Follow up comments / questions AR2, Castle resubmit 1.14.201 message

MEMORANDUM

Re: Review of DRMS Letter Dated December 18, 2019, Continental Materials Corporation January 9, 2020 resubmittal, and January 10, 2020 meeting

Re: Continental Materials Corporation/Castle Aggregate, Pikeview Quarry, Permit M-1977-211, Amendment 04, December 11, 2019 Operator Adequacy Answer Review.

Figure 1 – Pikeview Quarry – Detail of conchoidal fractures in the south part of the West Highwall, 2018.

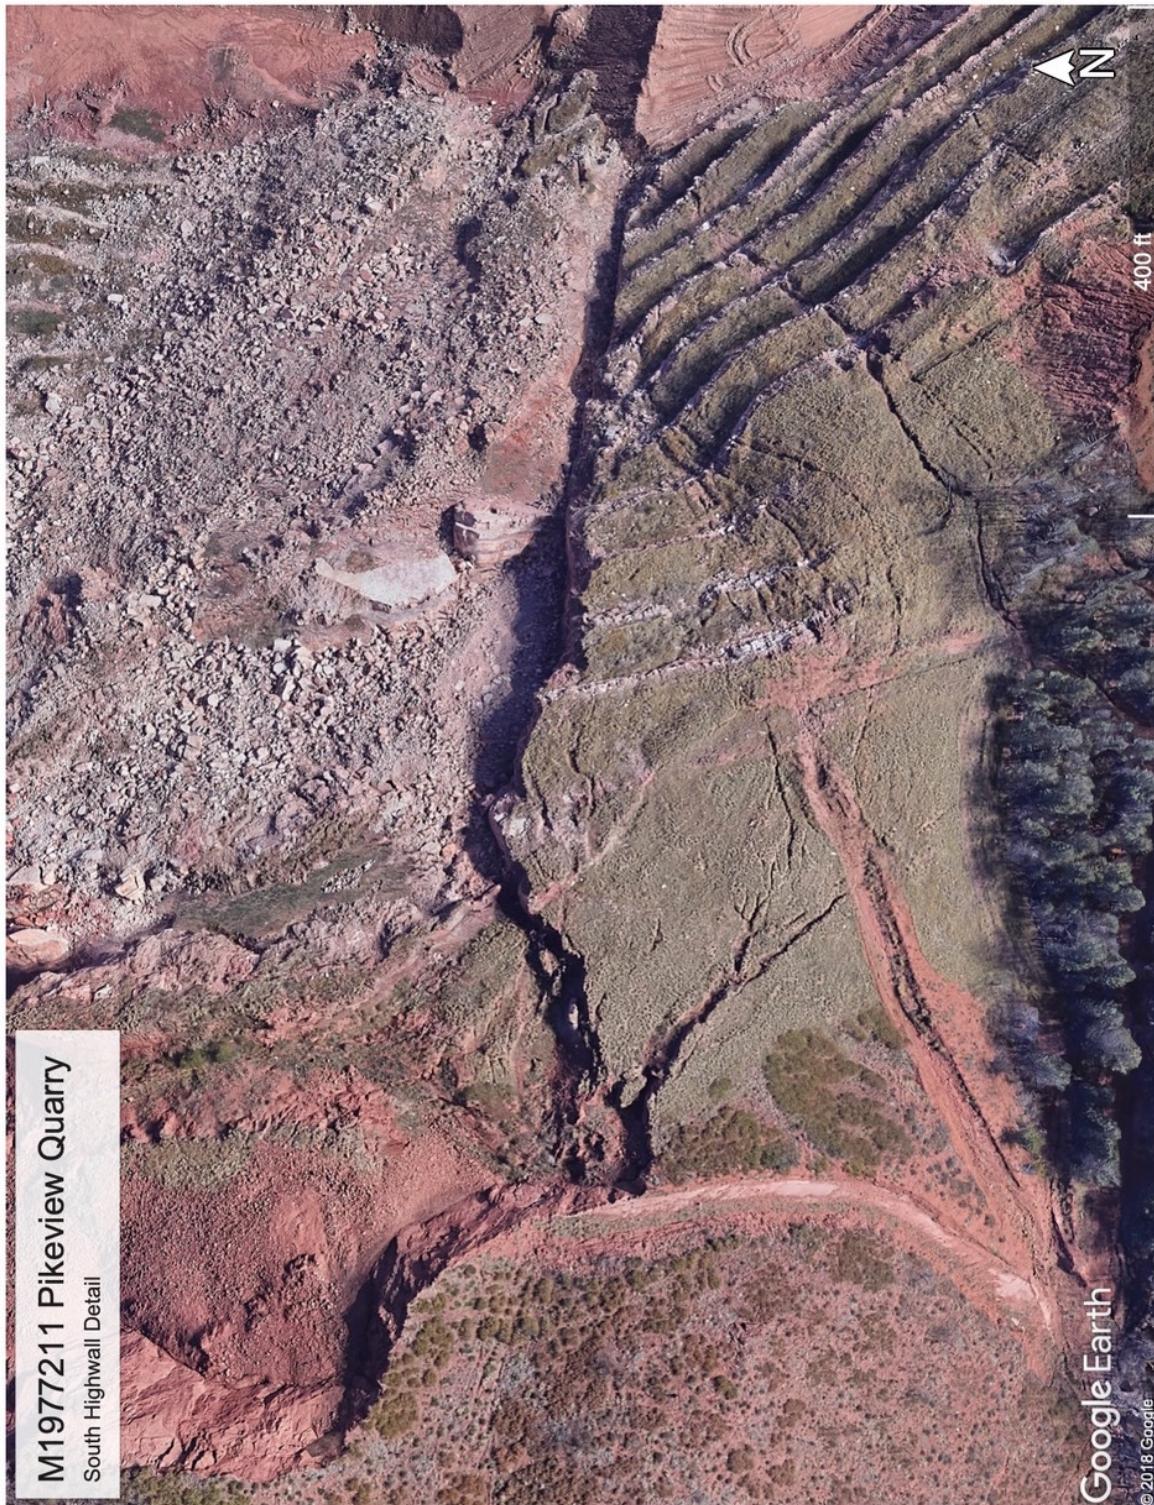
- 9. Review of aerial photographs (attached to this memo) from June 6, 2018 (available via Google Earth) indicate that there is another conchoidal tension crack and scarp developing in the upper south highwall of the quarry (Figure 1). Nothing in the mining and reclamation plans recognizes this or makes for any allowance to buttress this feature properly. None of the cross sections on Maps C-1 or C-2 intersect this possible hanging block of limestone material. DRMS and the operator need to address this dangerous situation.

Figure 6 – Detail of West Highwall showing breaches in the informal upland surface water control structure.

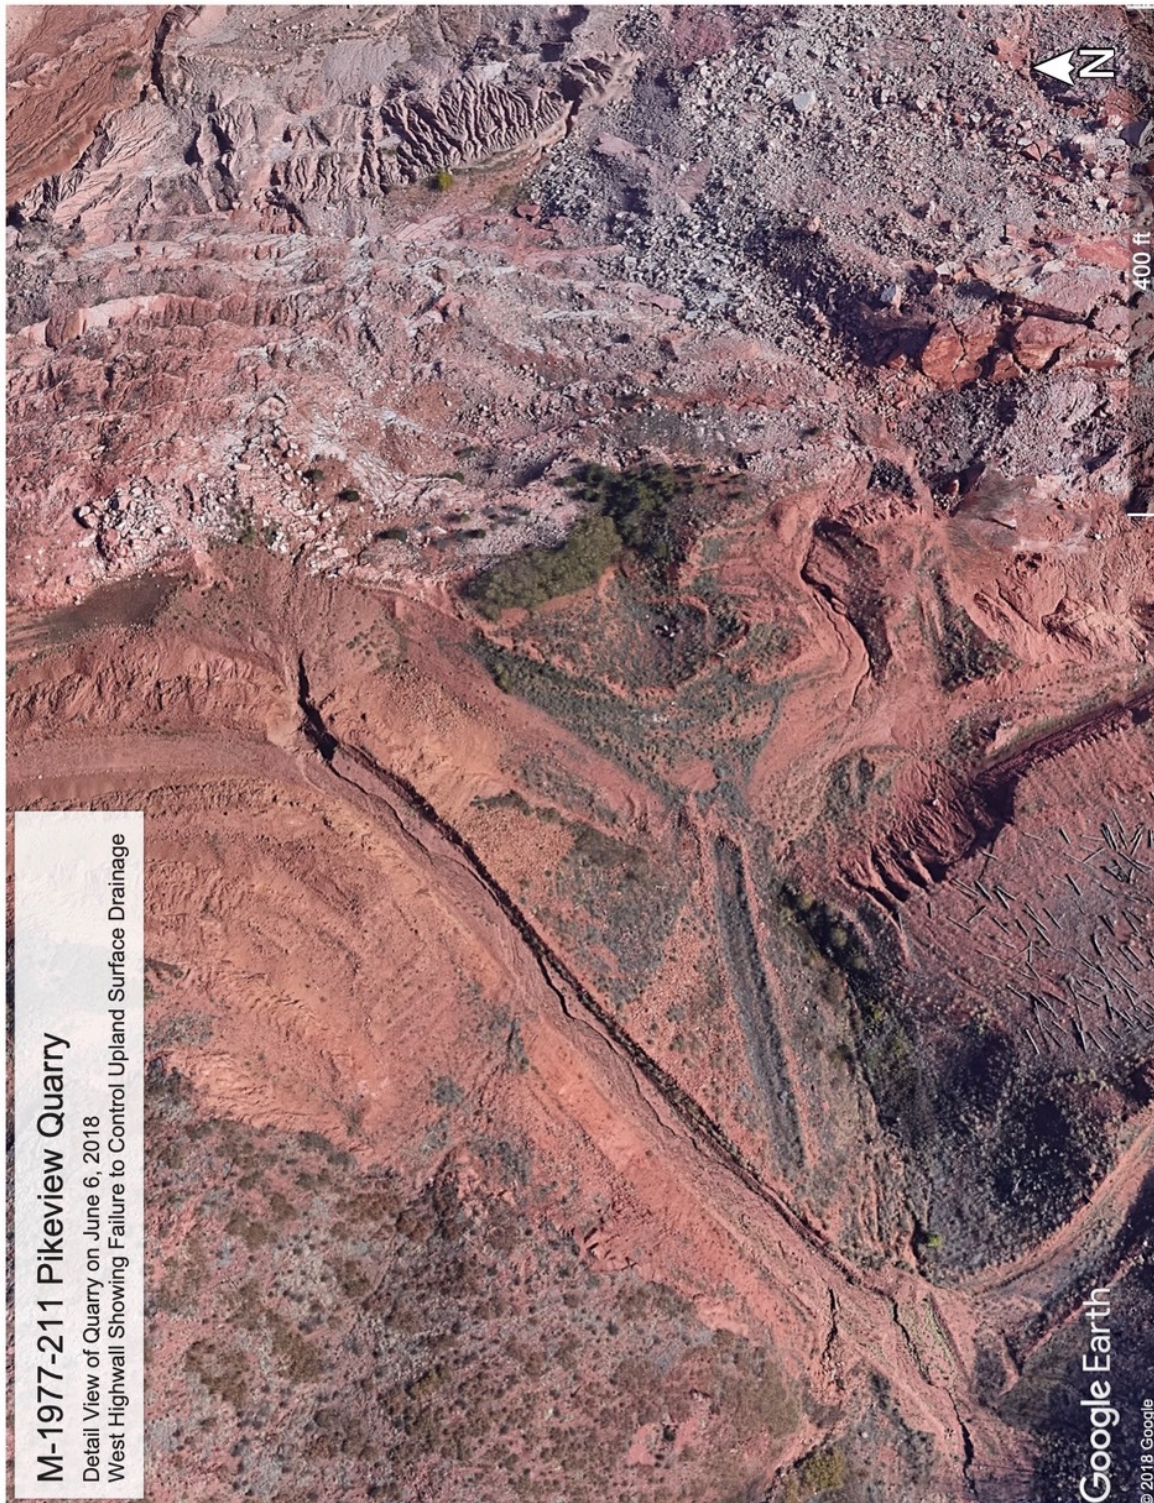
21. The reclamation plan states, "Surface runoff from the hills above the disturbed areas will be diverted around the stabilized and reclaimed slope." The informal drainage diversions in place prior to the 2015 rainstorm and subsequent slide, attributed to the rainstorm by the operator, failed and allowed surface drainage onto the site in at least two places. Photos taken the next day by DRMS showed water cascading down the face of the quarry. The Google Earth aerial photos of 2018 attached to this memo show that the informal upland diversion ditch has breached in at least two places above the quarry highwall scarp. This problem has been noted in the DRMS adequacy review letter (2012) of AM03 and ignored by the operator. The informal upland diversion ditch is not preventing upland runoff from entering the quarry and has not for at least 7 years. Good engineering practice would

include keeping upland surface runoff away from the engineered buttress fill to enhance buttress stability. Why is DRMS not asking for this?
